| Illinois Tollway Base Sheet Revisions | | | |
| Section M | Base Sheet Drawings | | |
| | Drawing | Modification Summary | Effective: 03-31-2016 |

M-ITS-1400

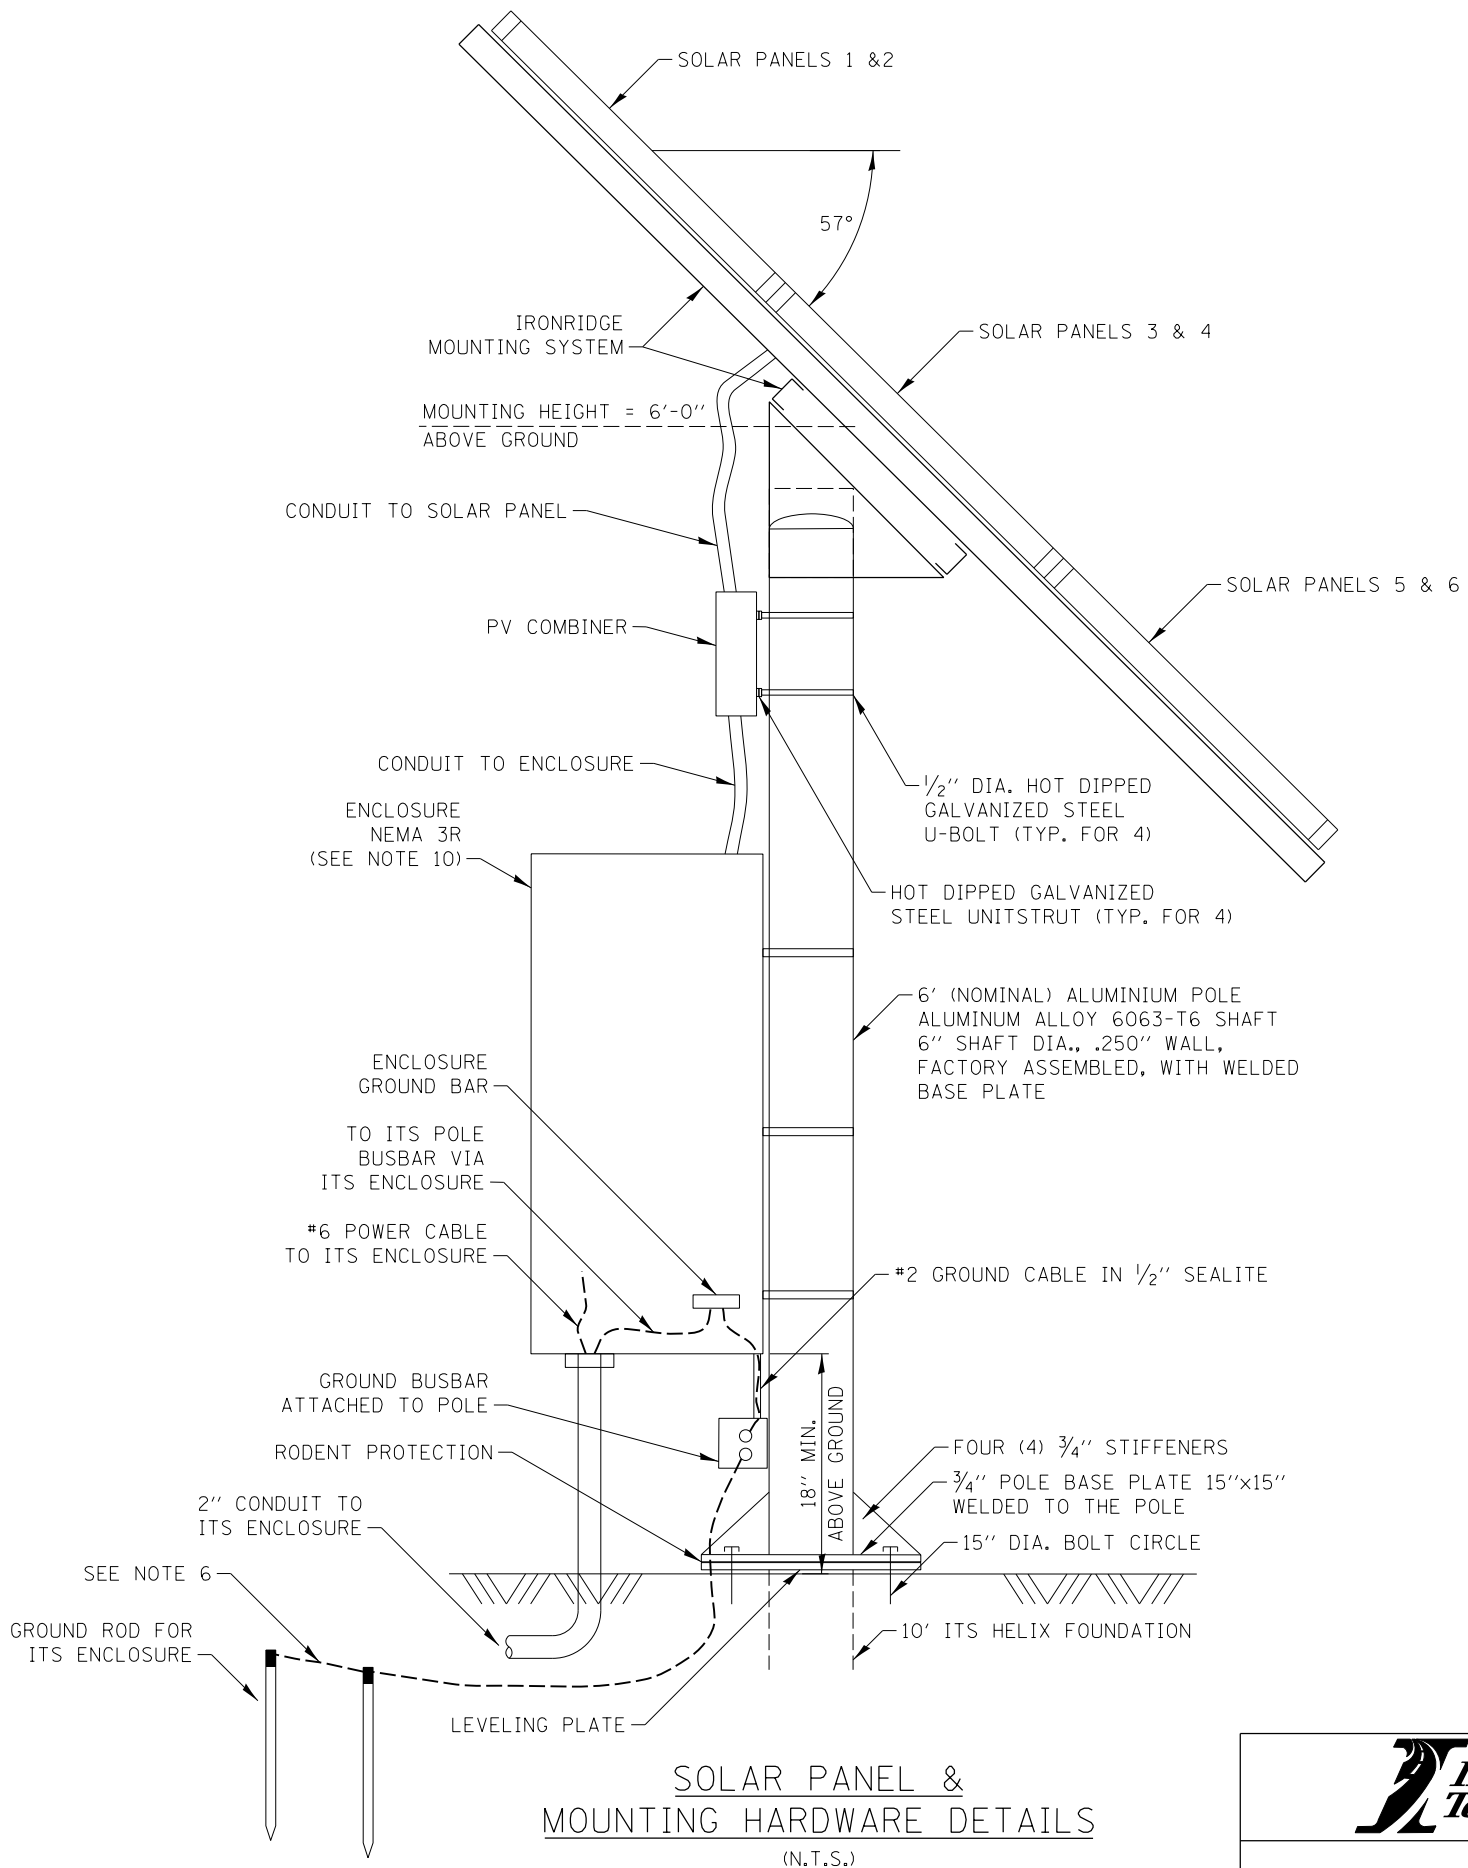
New Sheet
